10 August 2010  
Ref 08138

**Proposed Mixed Use Development  
Albert Street and Thomas Street, Chatswood**

I respond to your request to consider and provide advice in relation to the 'traffic issues' raised by the Department of Planning as follows:

**SWEPT PATH ANALYSIS  
OF A 9.6m REFUSE  
VEHICLE ENTERING AND  
EXITING THE SITE**

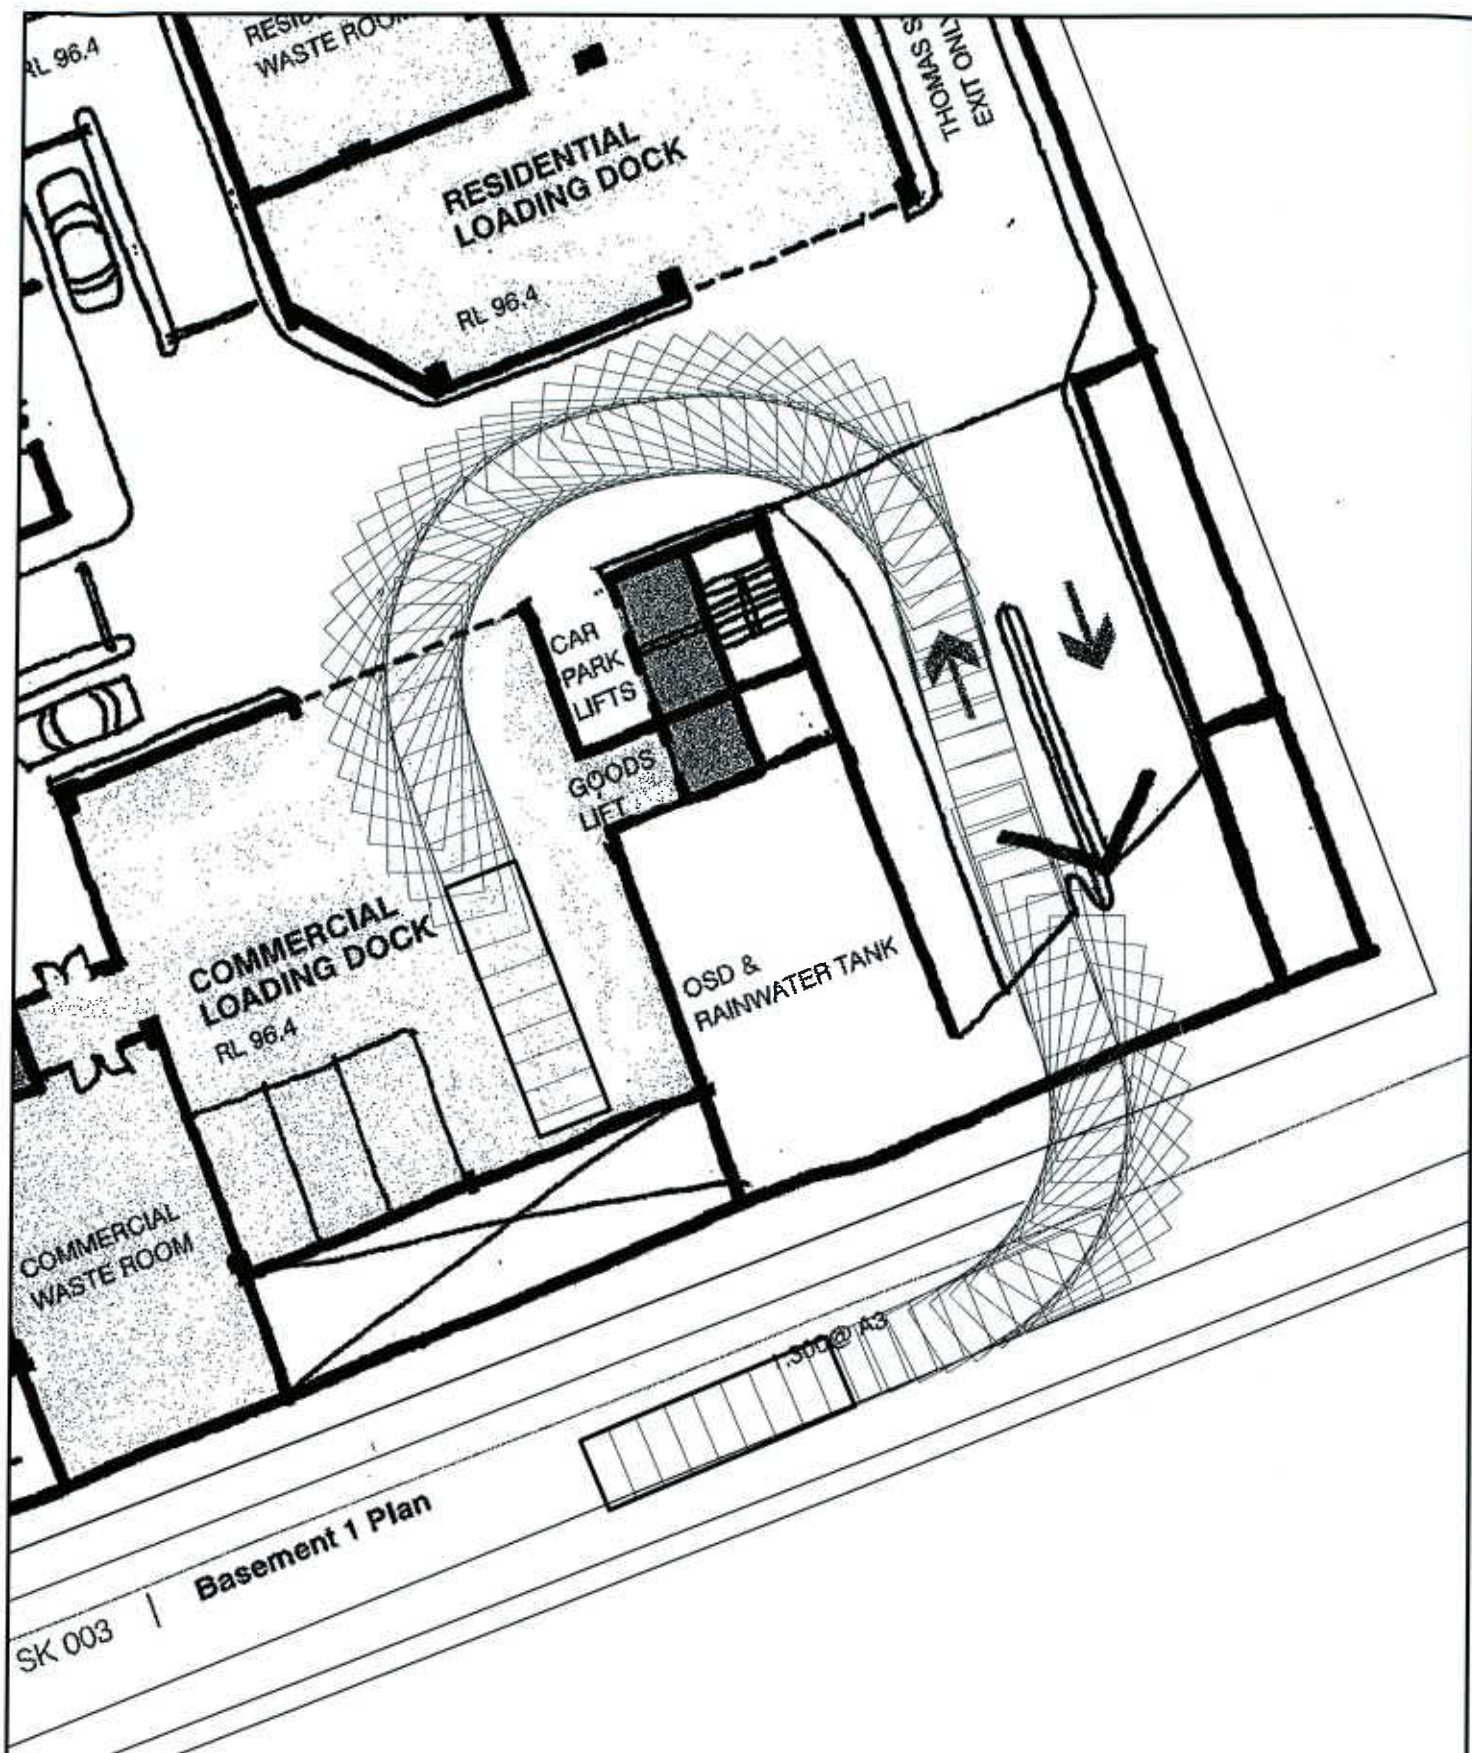
- \* the Traffic Report contained Appendix D which included the turning path for a garbage truck. In order to clarify the truck turning ability the attached turning path is provided indicating the ability for effuse trucks to negotiate the proposed driveway. In relation to the potential traffic conflicts of vehicles using the exit ramp and entering the right-of-way on Thomas Street the attached concept sketch prepared by PTW clearly indicates that:
  - the connections to Thomas Street would be simple ingress and egress driveways located so as to comply with the requirements of AS 2980.1. Any conflicts will be clear and unambiguous as that of any driveway/s onto a public road. The envisaged arrangement will be entirely normal and without any adverse traffic implications.

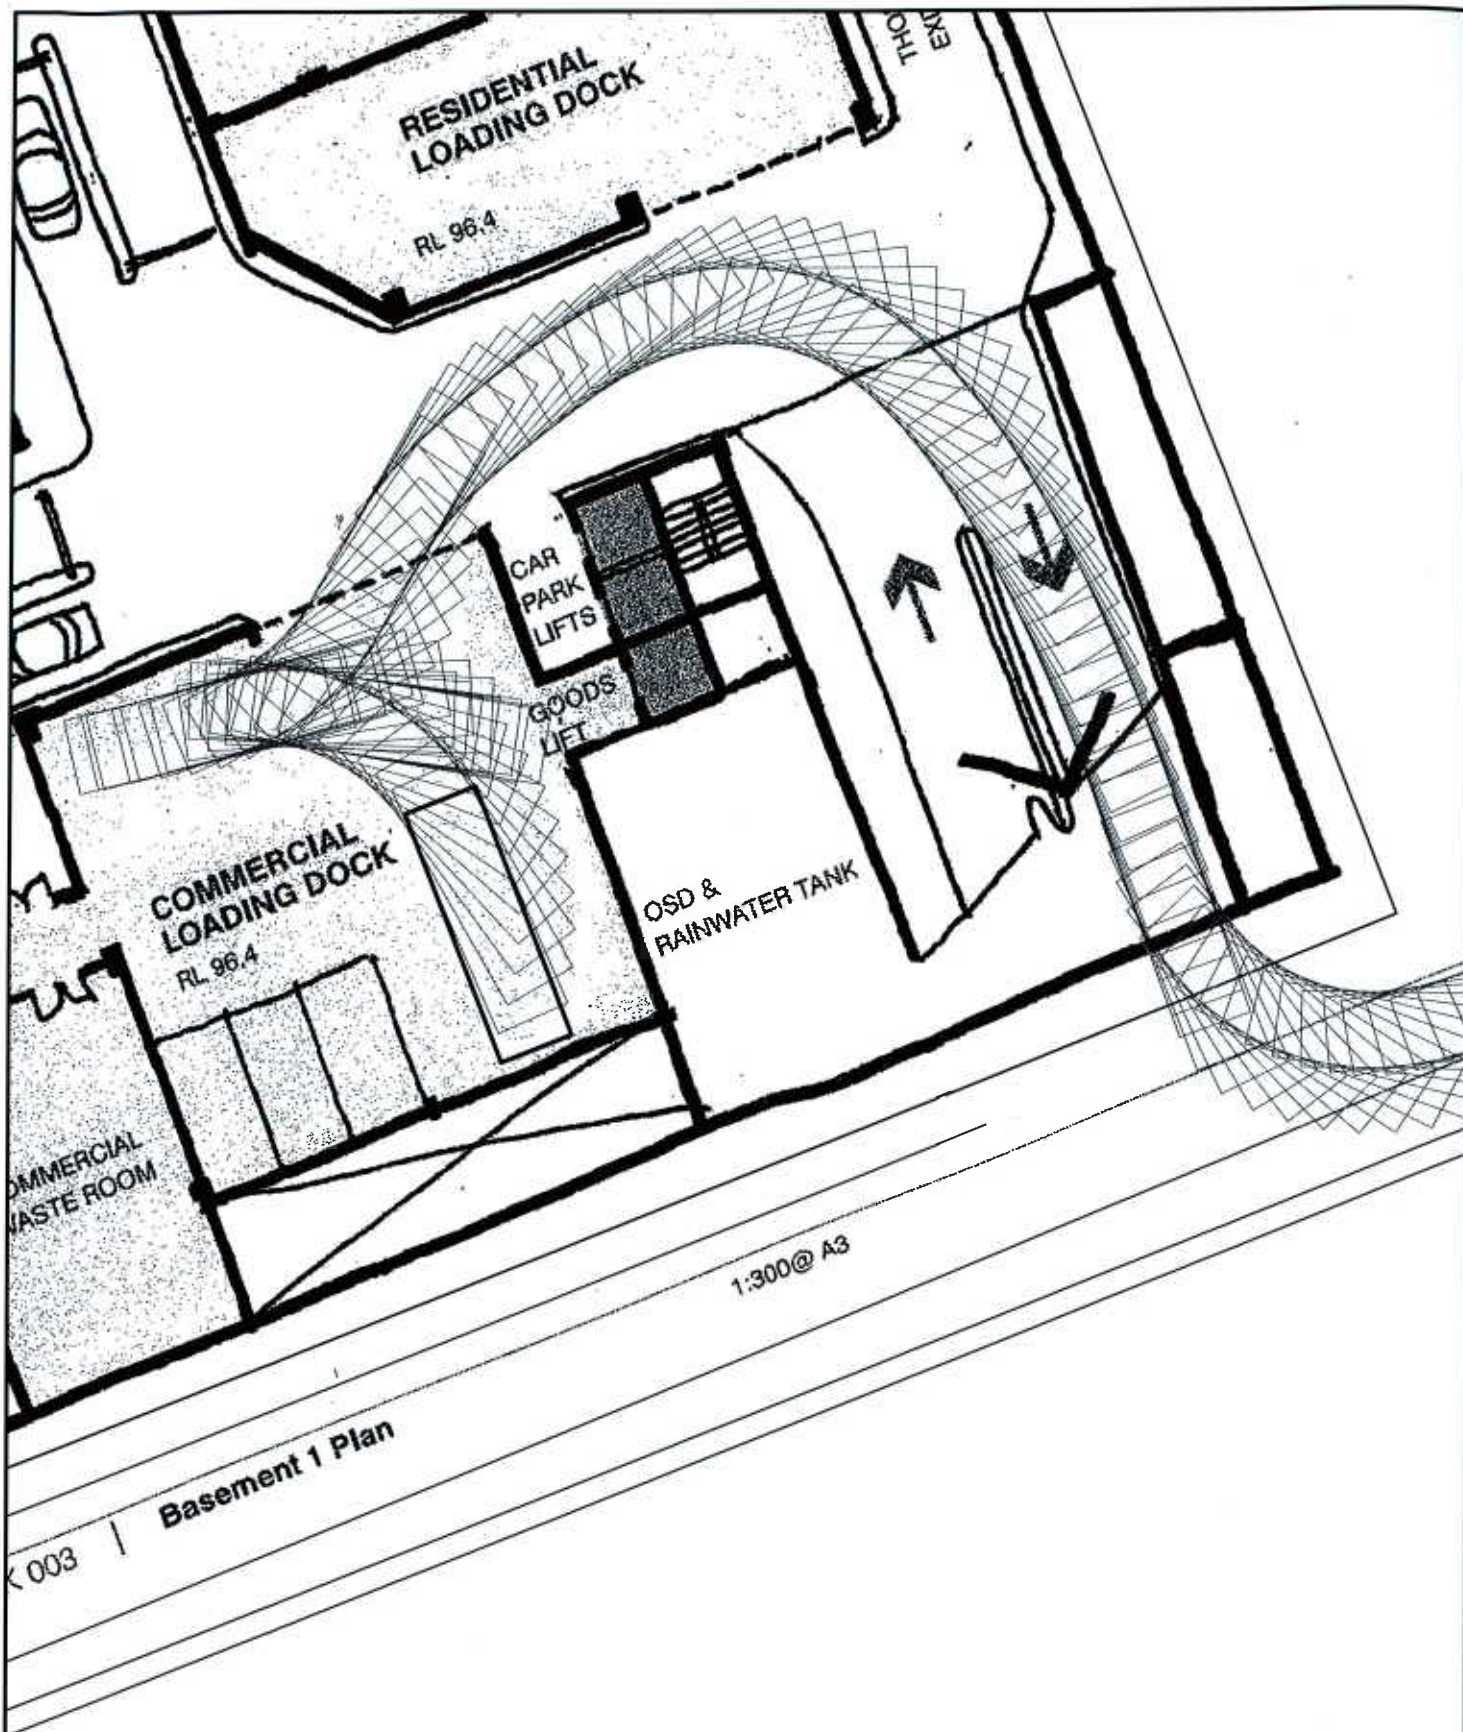
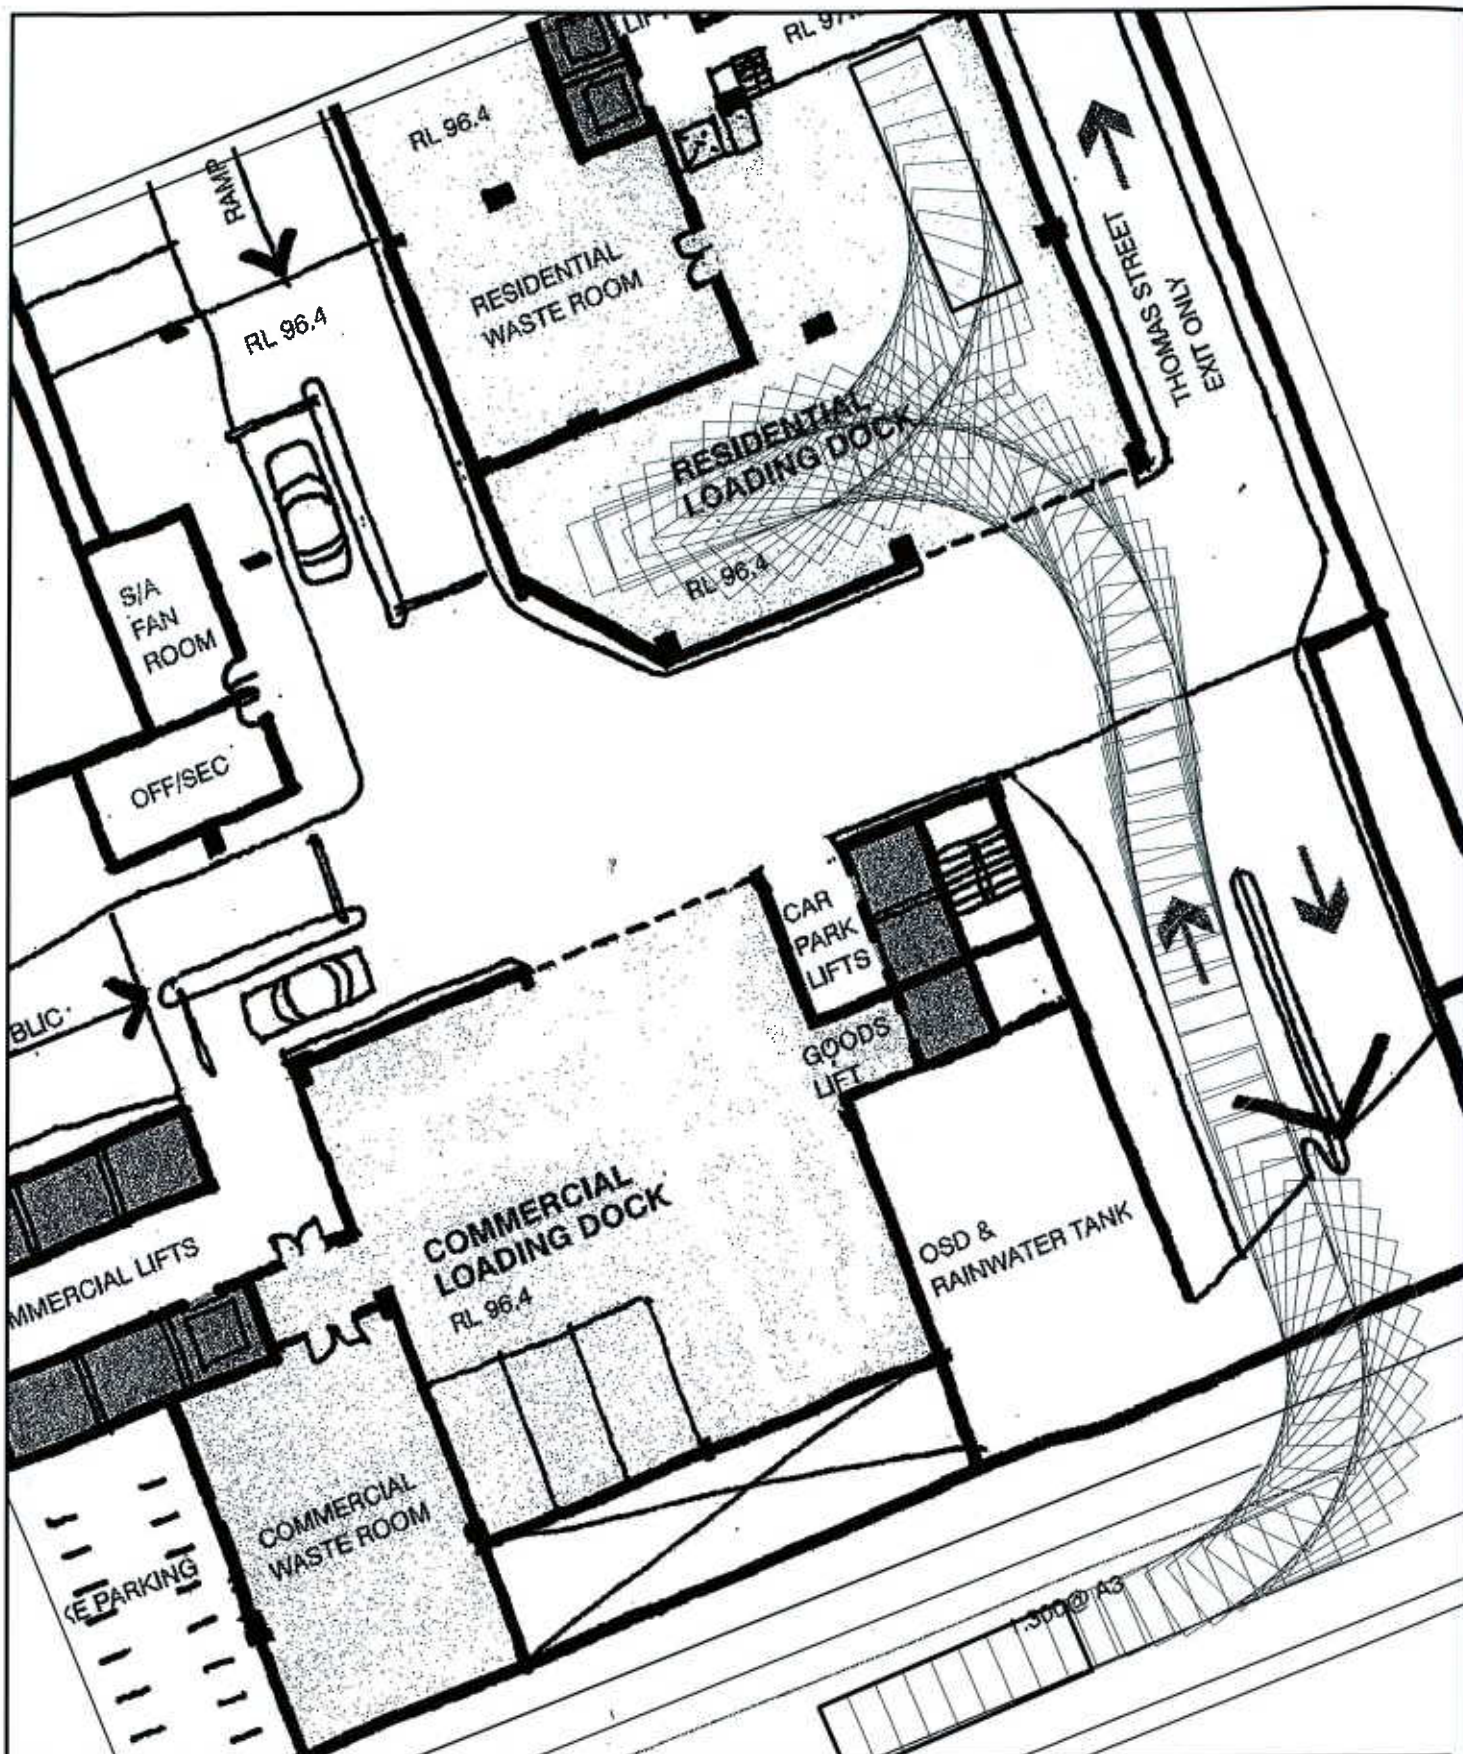
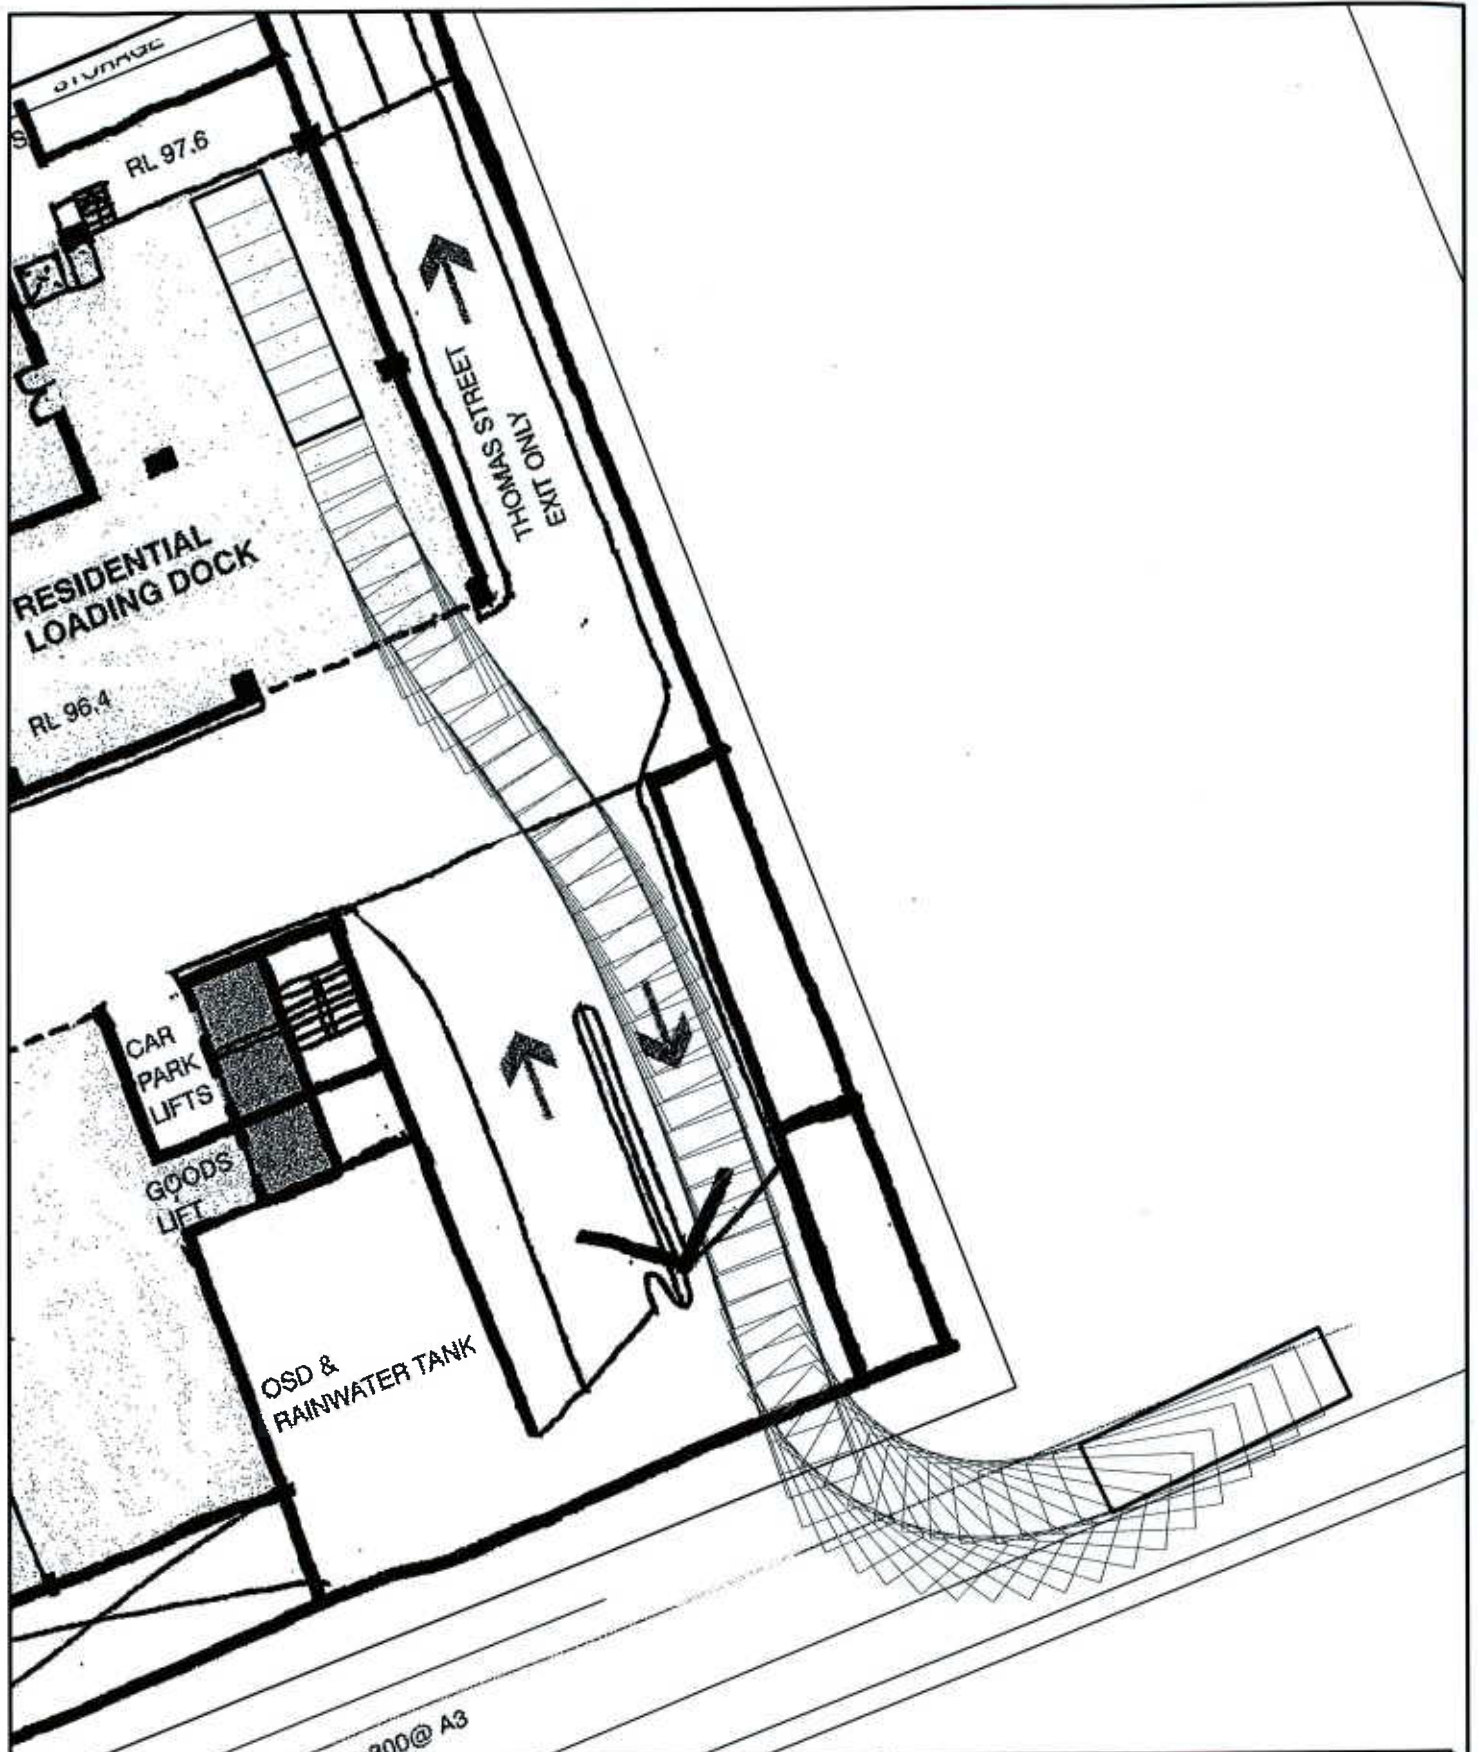
In relation to the ability for trucks to turn within the alternative loading dock arrangements (as shown on the PTW sketch) the attached turning paths SP1-8 clearly demonstrate the ability for MRV and refuse trucks to ingress, turnaround and egress.
